UNITED STATES PATENT AND TRADEMARK OFFICE

Office Action Summary	Application No. 10/667,056	Applicant(s) MCFERRAN, SEAN	
	Examiner Phillip Gray	Art Unit 3767

DETAILED ACTION

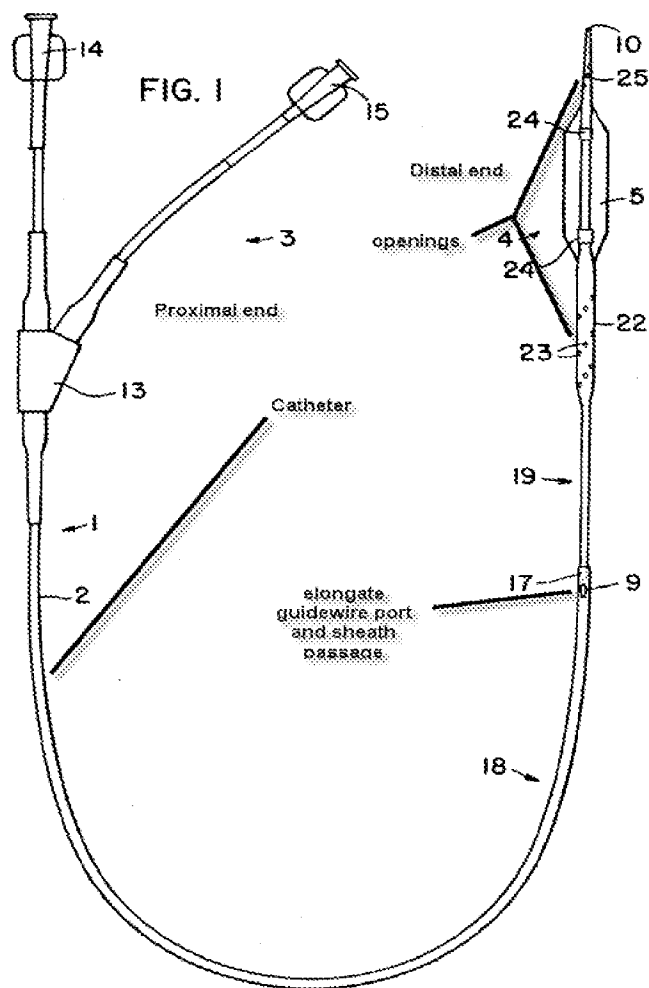
It is examiners position that Allman is not being used to teach the slit length, Pfenninger is discloses this slit length less then the sheath length. Pfenninger shows a slit length less then the sheath length in figure 3 below.

Concerning i) a slit extending at an angle such that the slit has a depth measured from the inner surface to the outer surface of the polymer sheath that is greater than the thickness of the wall of the polymer sheath, both Pfenninger and Allman teach this as would any slit on an angle less than 90 degrees to the outer surface (see Pfenninger figure 3 and Allman figure 4B or 4C).

Concerning the newly added claim language where the slit extends at an angle less than 90 degrees to the outer surface of the sheath again note Pfenninger at figure 3 and Allman at figure 4B and 4C.

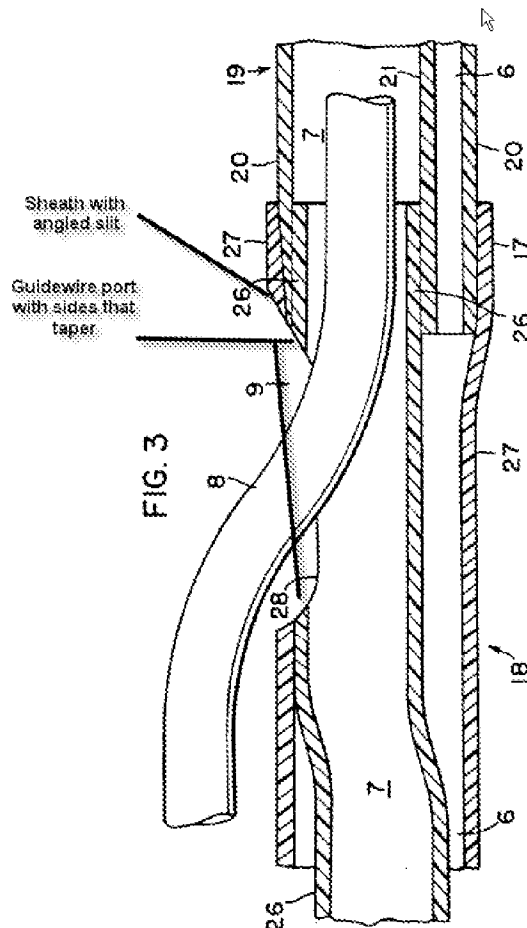
Pfenninger discloses a catheter (near 2) comprising an elongate shaft having a distal and proximal end fluidly connected to an opening (25/23) at the distal end of the elongate shaft, an elongate guidewire port (near 9), and a polymer sheet with a passage over the guidewire port (see marked up figure 1)

Further note the Sheath (27), angled slit see figure below, guidewire port (near 9 or 28) with tapered walls (see marked up figure 3 below).

Concerning claim 15-16, see near 27 in figure 3.

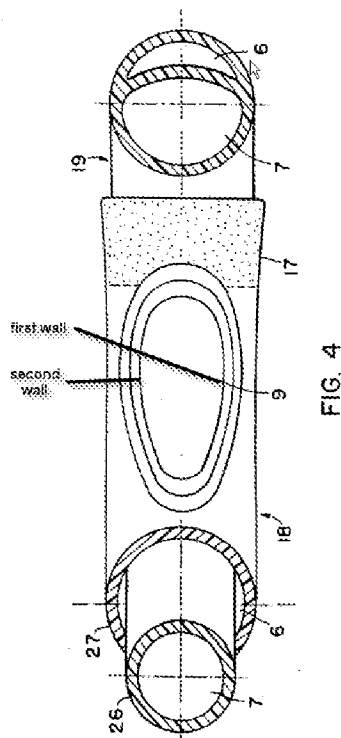
Concerning claim 23 see marked up figure 4 below. Concerning claim 24 note slit length is larger then port length. Concerning claim 25-26 note port near 28 tapered edges as in figures 3 and 4.
